SERVICE INFORMATION LETTER NO. T-034

Revision 1

1. SUBJECT: Sliding Window Installation
2. MODEL: TH-28, 480, and 480B
3. EFFECTIVITY: All
4. BACKGROUND:

**Figure 1**

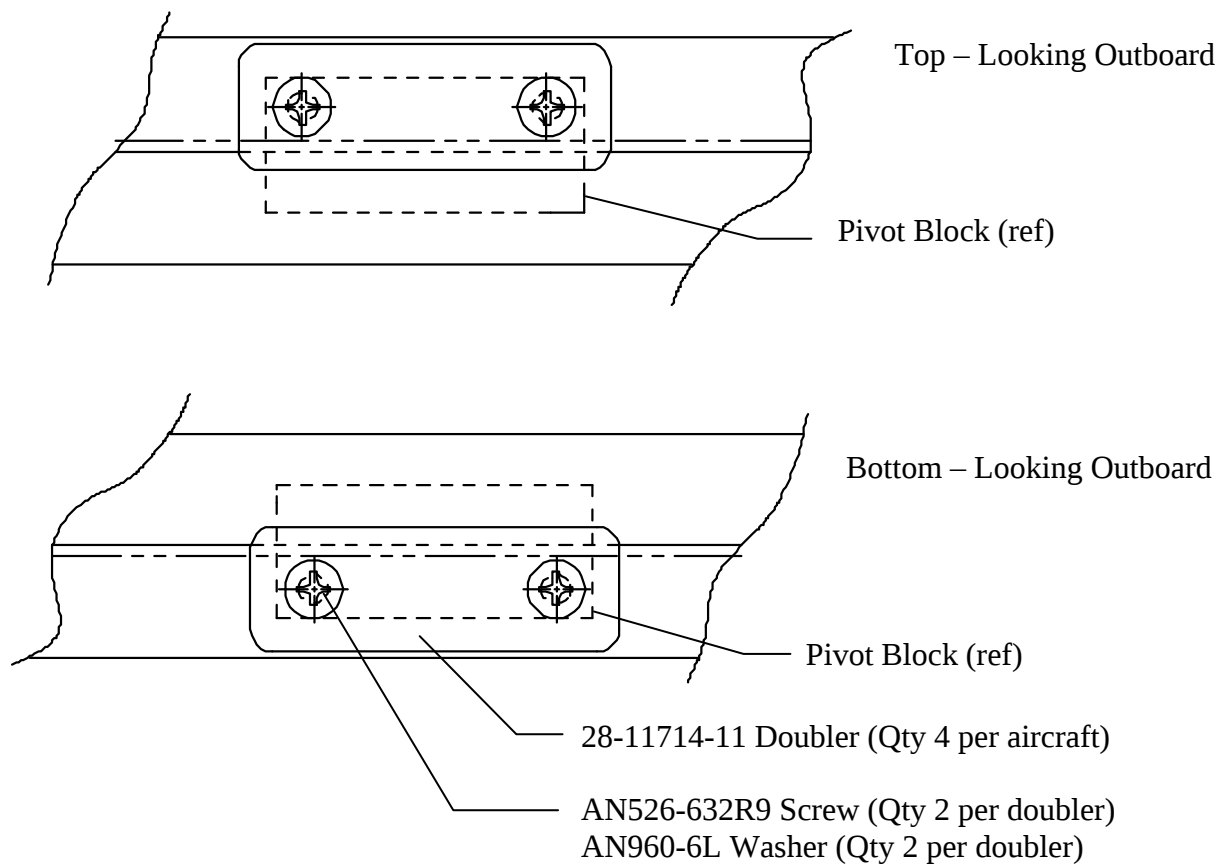
Revision 1 incorporated the following changes: aluminum doubler was acrylic, washer AN960-6L was MS51859-15, screw AN526-632R9 was AN526-632R6, and the bonding procedure was removed.

Enstrom has received reports regarding cracks generated about the sliding window frame at the location of either the upper or lower vent window pivot blocks. The cause for cracks has not been identified but may be attributed to the quality of the workmanship during production assembly, such as overtightening hardware and/or improper deburring of the attachment holes in the acrylic window structure. For an improvement, Enstrom has designed a doubler installation to reinforce the door window in the area of the pivot blocks.

- A. Slide the window aft to avoid damaging the window during the doubler installation.
- B. Remove the two screws that are installed from the inside of the window that screw into the wing window hinge blocks.
- C. Inspect the screw holes for cracks. If cracks are detected, contact Customer Service.
- D. Position the doubler by aligning the two attachment holes of the doubler with the two holes used to attach the pivot block. See Figure 1.
- E. Install the attachment hardware listed in paragraph 5.2 (8 in-lb max. torque).

CAUTION**Do not overtorque hardware.**

- F. Repeat Steps A through E for the three remaining doublers.
